F.A.O: Wokingham Borough Council Planning

Objection submitted by: A A Butler: Address: Cranford Drive, School Road, HURST RG10 0ET
09/02/2025

Re: Planning Application: 252934 – Land at Lodge Road Hurst, RG10 0SG

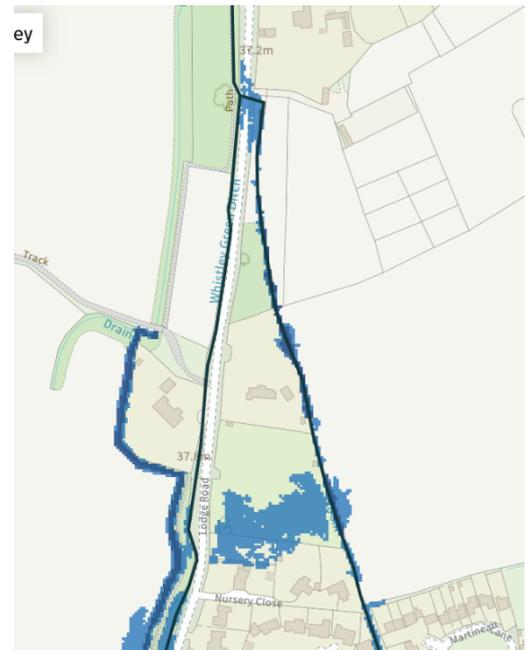
(1.0) The Applicant's **PLANNING FORM REDACTED 252934 "Assessment of Flood Risk"** appears to have been completed incorrectly. Three of the "Yes" or "No" statements need to be reviewed by WBC Planning and resubmitted correctly by the Applicant as follows:

(1.1) **"Is your proposal within 20 metres of a watercourse (e.g. river stream or beck)?"** - Answer given by Applicant **"No"**; should not the correct answer be **"Yes"**?

Figure 1: Site Location Plan

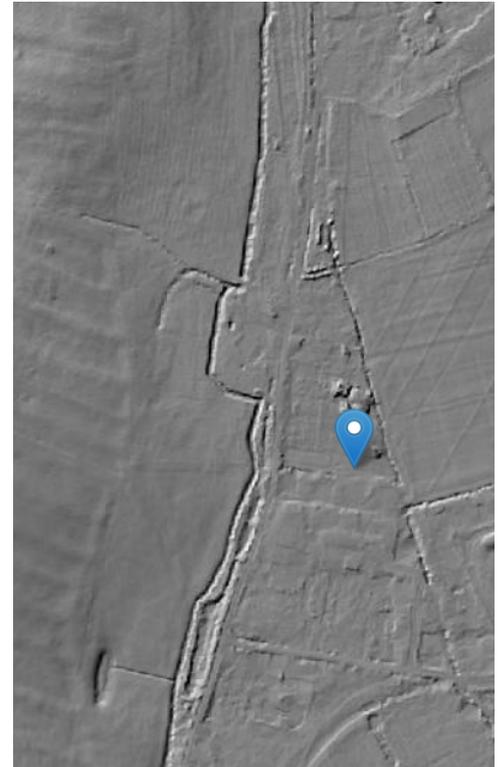
(1.1.2) Consider Applicant's FRA submission "Figure 1": Looking at page (2) of the Applicant's "Flood Risk Assessment, Site Location & Topography, Figure 1: Site Location Plan"(part shown in the screenshot right and below). The Applicant's map identifies in red the boundary of a marshy 37m AOD proposed site in the context of immediately surrounding land and drainage ditches. Low-lying 37m AOD land vulnerable to flooding lies to the south, east and north of the site. Higher man-made capped waste landfill lies to the west, where beyond Lodge Road shown at 38m AOD the waste hill rises to 45m AOD with its increased pluvial storm water run-off* now east towards Lodge Road and the site.

Plot East Side: The Hatchgate Ditch tributary marking the eastern boundary of the site is marked in blue and annotated "Drain". Clearly the Applicant's own documentation again shows this site boundary within "0"metres of a watercourse. Hence considering the eastern boundary along the Applicant's own submissions (Figure 1 and full map FRA APPENDIX 1 Site Location plan) require a "No" response to be changed to "Yes". This degraded eastern boundary ditch is shown correctly terminating on Application: 242067 plot, but the watercourse flow direction arrow indication is clearly wrong indicating an impossible flow north along the closed ditch with no outlet. Any ditch flow or drift will be south towards existing low-lying development* to the south in the lower western arm of Hurst's "reversed "C" development*.

**With the site's east boundary "Drain" only draining south, what is not shown on Figure 1 in the low-lying Sawpit triangle opposite Martineau Lane, is the new development "Little Acres" which, with no infiltration drainage and larger than expected, has itself already added to local surface water drainage issues. Similarly, the Applicant's larger APPENDIX 1 Site Location Plan also does not show the Little Acre "Sawpit" development, which is also not yet shown on normal Ordnance Survey maps.*

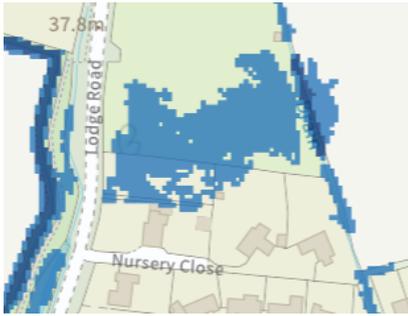
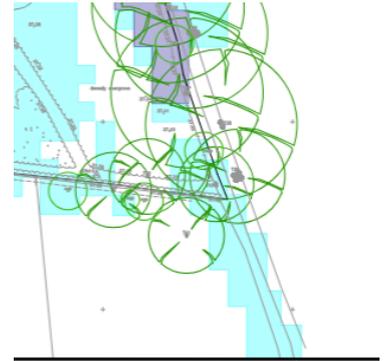
A March 2023 photo (right) shows surface water flooding crossing from the flooded Application: 252934 site and eastern boundary ditch towards and across the neighbour’s property in Nursery Close.

whose flood risk will be increased by the Applicant's development, hence requiring a "Yes" answer to the flood risk question.

GOV.UK Flood Zones Map*screenshot (left) shows zone 2 and 3 fluvial flooding impacting Application: 252934 plot and boundary ditch but not predicting actual flooding extent into the neighbouring Nursery Close garden pictured (above).

Flood map for planning

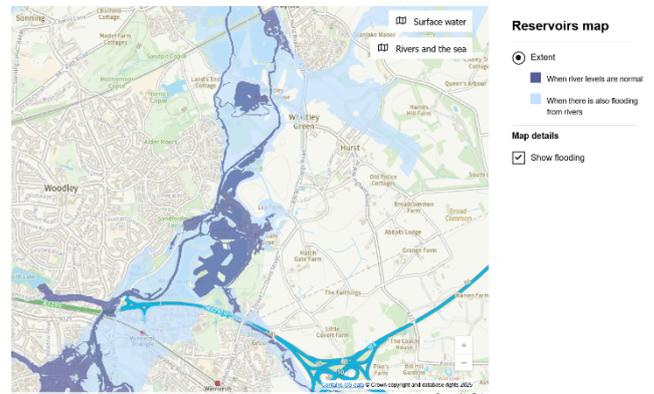
Also in the current GOV.UK/EA/OS Flood Map for Planning photoshot (left) is the absurd designation on the top of the nearby 44m AOD western landfill hill, 7m higher than

Application: 252934 37m AOD site, as Flood Zone 3. With two such very obvious errors within only a small area of Hurst should not WBC as LLFA be advising this online data for Hurst should carry a suitable warning "[GOV.UK responses may include errors](#)"?
